Date	Expiration	Release	Page
02.2013	02.2015	1	1

REPLACEMENT OF SILICONE HOSES, ENGINE COMPARTMENT Prevost vehicles

Figure 1:503784 (17)

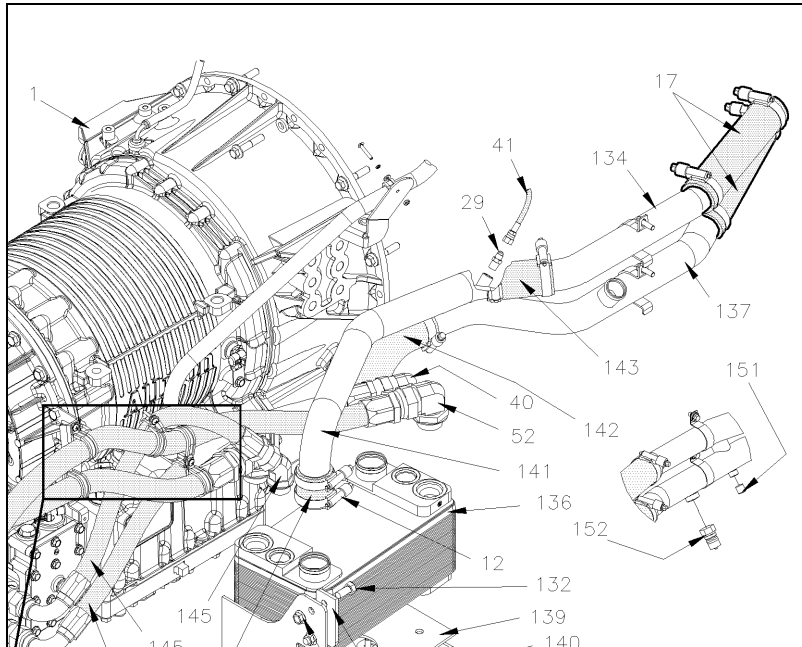
On the vehicles affected by this bulletin, improved silicone hoses are available. Proceed to replacement at next service occasion.
